UNITED STATES ENVIRONMENTAL PROTECTION AGENCY

SUBJECT: Tyson's Dump Site

As I had informed you at our last meeting on September 5, 1985, EPA and Ciba-Geigy appeared to be in reasonable agreement on the scope of work to be performed in four of the five Operable Units at the Tyson's Dump Site, however the fifth Unit, "Floodplain/Wetlands" was still under evaluation by EPA. Since that time, I have met with personnel with EPA's Environmental Impact and Marine Policy Branch and also the U.S. Fish and Wildlife Service to discuss a reasonable approach in assessing contamination in the Floodplain/Wetland Area. As a result of these meetings, EPA is proposing that the following work be performed on the Floodplain/Wetlands Area:

FIGURE 1: OPERABLE UNITS STUDY
LOCATION MAP FOR ADDITIONAL
SAMPLING ACTIVITIES

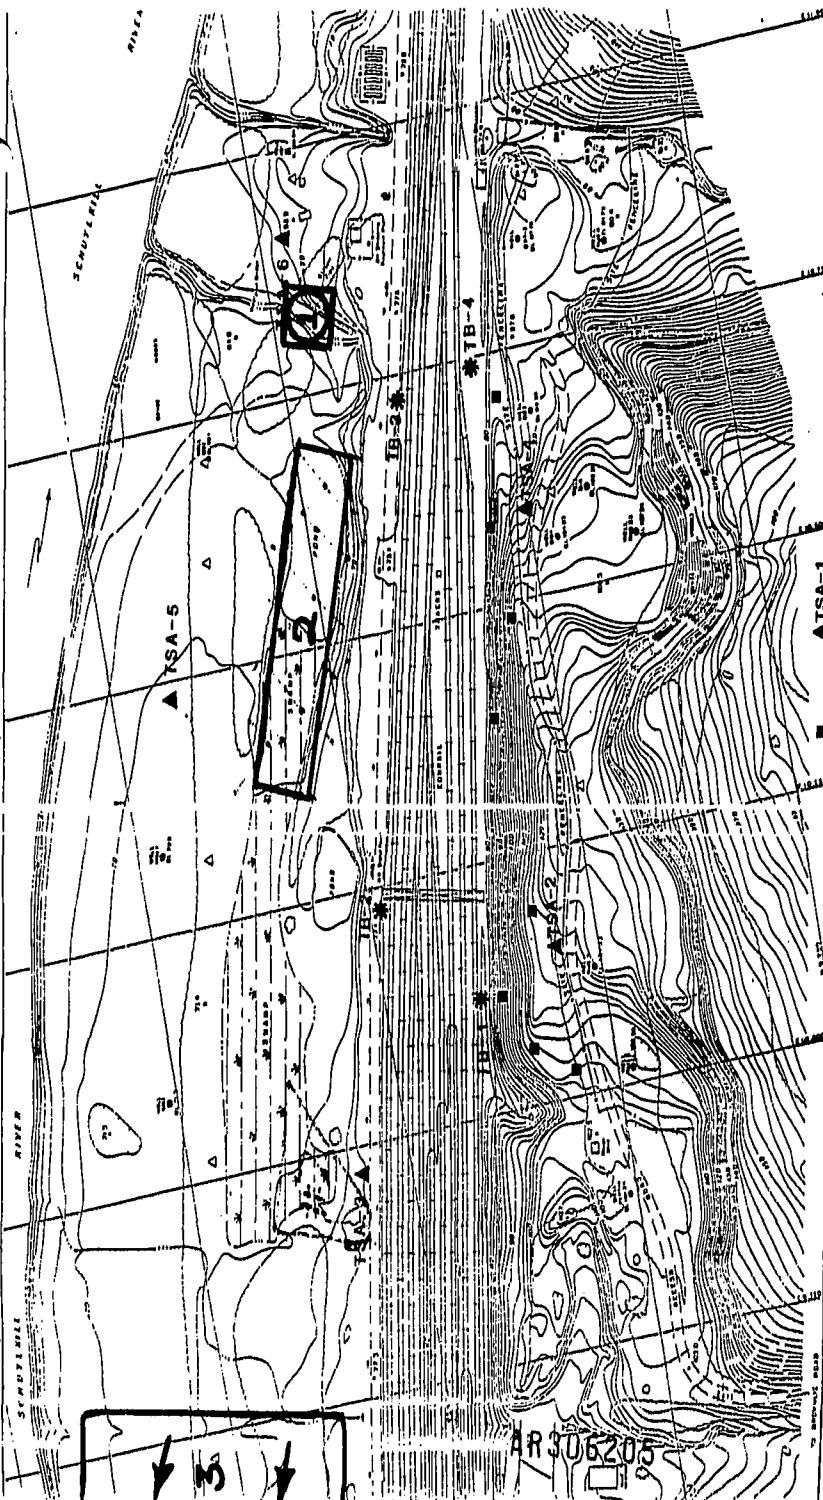
B. Sediment Samples - Composite sediment samples will be collected at the (area 1) outfall of the air stripper effluent and (area 2) westernly swamp area (see attached map). Analysis of these samples are to include both acute and chronic bioassays, as well as a complete scan for the EPA Hazardous Substances List (HSL). The bioassays should be performed by standards which include a seven day chronic growth test and a life cycle test. Both acute and chronic bioassays will provide LC_{50} , however the 7-day chronic growth test on Pimephales promelas should be used to assess the potential of long term toxicity. Because of its sensitivity, it is recommended that the 7-day life cycle tests on Ceriodaphnia sp. also be used.

The sampling strategy in this Study Area during EPA's Remedial Investigation concentrated on areas that appeared to be most likely affected by runoff from the leachate collection system as well as areas affected by surface drainage patterns. Because of this strategy, a representative sample of background soil was never determined. Therefore, in order to assess what might typically exemplify the native soil in this area a composite soil sample will be collected in the background area (area 3) and analyzed for the HSL.
